# Vehicle Surge Between 40 and 50 mph

**Service Category** Drivetrain

**Section** Automatic Transmission/Transaxle

YEAR(S)	MODEL(S)	ADDITIONAL INFORMATION
2016 - 2017	Tacoma	WMI(s): 3TM, 5YF VDS(s): AZ5CN, BZ5DN, CZ5AN, DZ5BN, EZ5CN, GZ5AN, HZ5BN, RZ5CN, SZ5AN Engine(s): 2GR Transmission(s): 6AT

**Figure 1. Location of Authorized Modifications Label for 2016 – 2017 Tacoma**

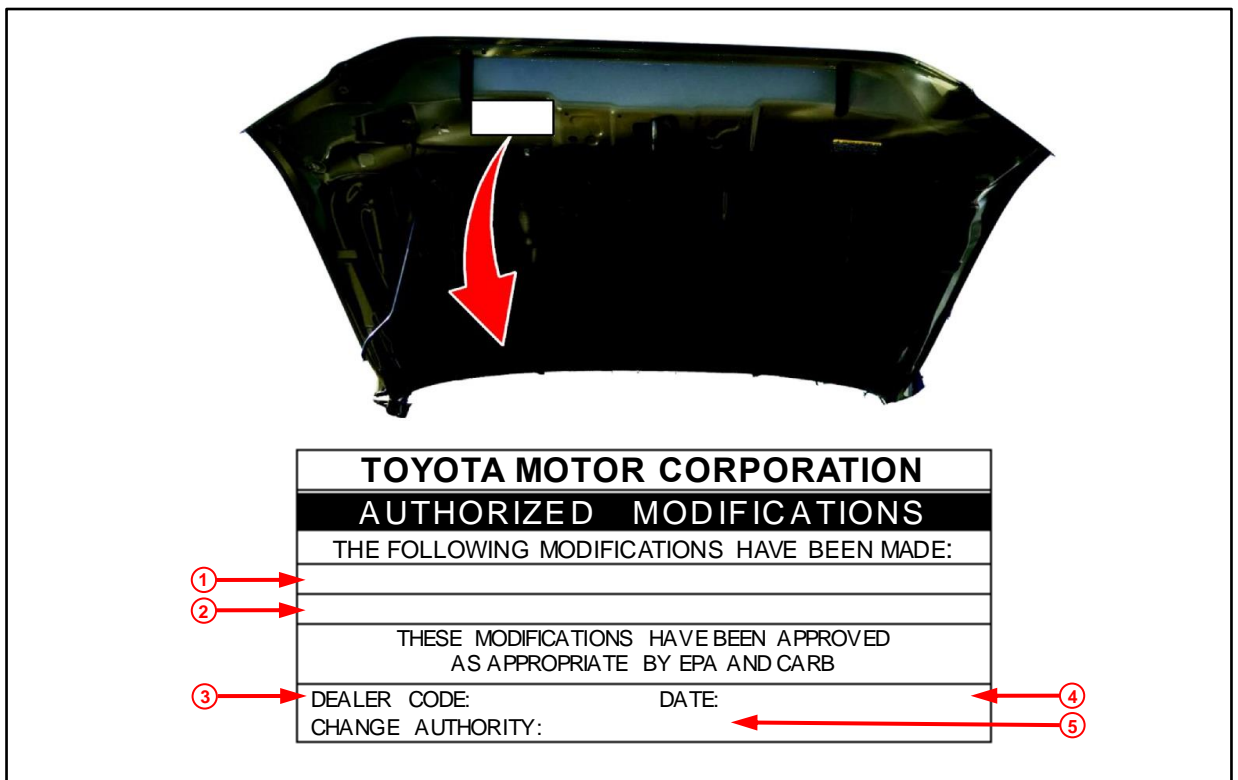
2. Check for the Authorized Modifications Label affixed to the vehicle in the location shown below. Confirm if the ECM (PCM) calibration has been updated.  
Is the calibration ID listed the latest ECM (PCM) calibration?
  - **YES** — This bulletin does NOT apply. Continue diagnosis using the applicable Repair Manual.
  - **NO** — Continue to step 3.

4. Prepare and install the Authorized Modifications Label.

A. Using a permanent marker, enter the following information on the label:

- ECM part number [*Refer to the **Parts Information** section for the **NEW PART NUMBER***]
- Calibration ID(s) [*Refer to the **Calibration Information** section for the **NEW CALIBRATION ID***]
- Dealer Code
- Repair Date
- Change Authority [***This bulletin number***]

B. Install the Authorized Modifications Label on the vehicle at the location shown in Figure 1. The Authorized Modifications Label is available through the MDC, P/N 00451-00001-LBL.
